PERMIT

SEWAGE DISPOSAL SYSTEM

MARYLAND STATE DEPARTMENT OF HEALTH

SUBDIVISION _____ ROAD *Rt 97 1/2 N. of 70* LOT *3-B*

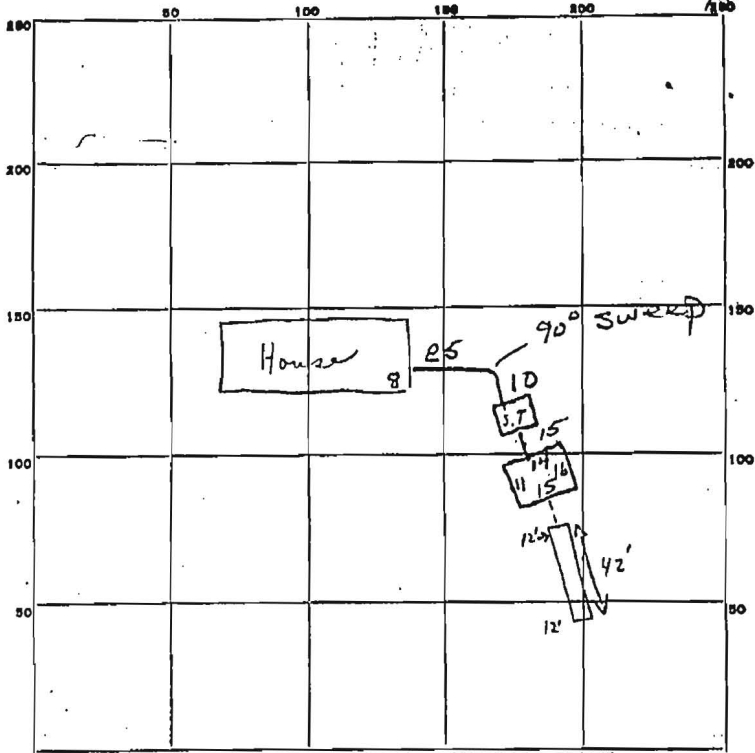
*Permit valid for 3 years.
All pipes from house to disposal must be cast iron.
Install stop in pipe in right tank to be dry used.
Stop in pipe must be 6" in dia, 10' long, cast iron and tested before acceptable.*

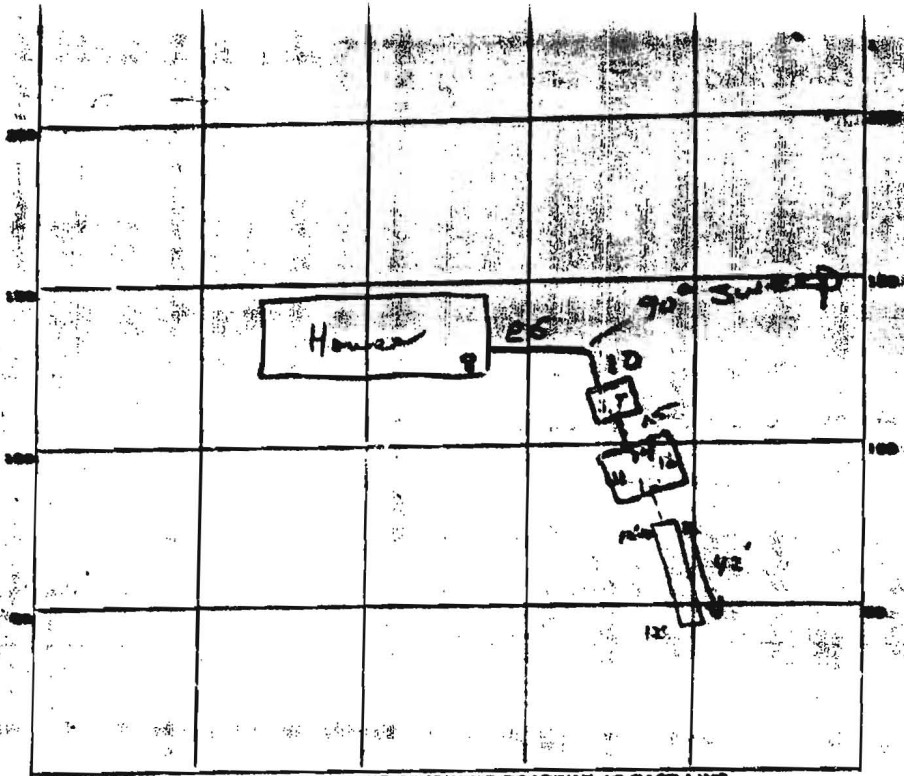
PERMIT CARD yes Not seen { kept note }
 SEPTIC TANK, LEVEL 1000 gal ok in c.I. pipe ok for ground S.T. | P.W.
 CLEANOUTS — | — 5' tall
 DISTRIBUTION BOX, LEVEL N/A

Trench
 TILE FIELD, DEPTH 12 FT. TRENCH WIDTH — FT.
 GRAVEL DEPTH 7 IN. TOTAL LENGTH 42 FT.
 NUMBER OF TRENCHES 1 one side TOTAL BOTTOM AREA 294 ft²
 SEEPAGE PITS, INSIDE DIAMETER 56 FT. DEPTH BELOW INLET 7 FT.
 ABSORBENT AREA ± SQ. FT. 392 292 686 ft² (Gas tight)

REMARKS 9/7/76 (3 or 4 Bedrooms) Trench ok for gravel only
9/15/76 at 10:30 hb - place paper on top of
stone in D.W.
